REQUEST FOR FURTHER INFORMATION – MURIWAI DOWNS GOLF PROJECT

TO: Reporting Planner – Auckland Council
FROM: Matthew Paul
DATE: 28.03.2022

Applicant: The Bears Home Project Management Ltd

Site address: 670 Muriwai Road, Muriwai Valley

Figure 1 – Updated plan showing access track to be used for construction and long-term maintenance

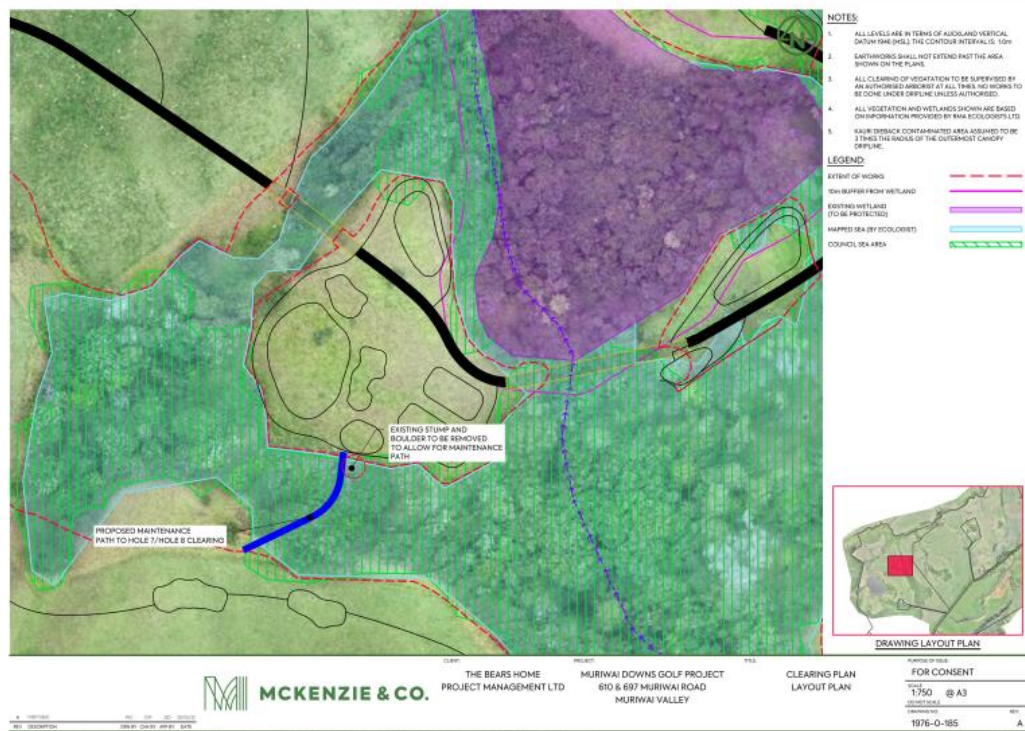
Maintenance/construction access to Green 7/Tee 8 (clearing within the SEA), is proposed via the use of an old farm track which is no longer used. This requires earthworks and tree trimming and the permanent loss of this area as SEA. It is also noted that no SEA loss or earthworks for the construction of the golf buggy tracks is shown in this location. Please update plans to show the earthworks and vegetation removal required to construct and maintain the greens/tees, bridges and golf buggy tracks.

Kohekohe tree T10 – This tree is proposed to be pruned in excess of the ‘trimming’ standard, to facilitate a machinery access track down to the 7th green. Please outline what track alignment options have been considered and discounted as it is considered that there is sufficient existing clearance for the track to be realigned to avoid the need for pruning and works in the root zone of this tree.

Following on site discussed with Council specialists and the project team, the proposed access has been re-aligned to avoid the Kohekohe tree, with the existing fallen stump to be relocated and track moved away from T10. This is reflected in the drawing 1976-0-185 illustrated in Figure 1.

A small amount of new fill (base course) at a maximum depth of 150mm will still be required within the protected root zone of T10 - to form the new access track. The area where the re-aligned track is to be located drops steeply away from the main informal farm track. As such, fill will be required to increase the gradient for all weather access.

Minor pruning (10% and up to 50mm branches) to lift the tree for construction and access so as to avoid machinery conflict in the future.
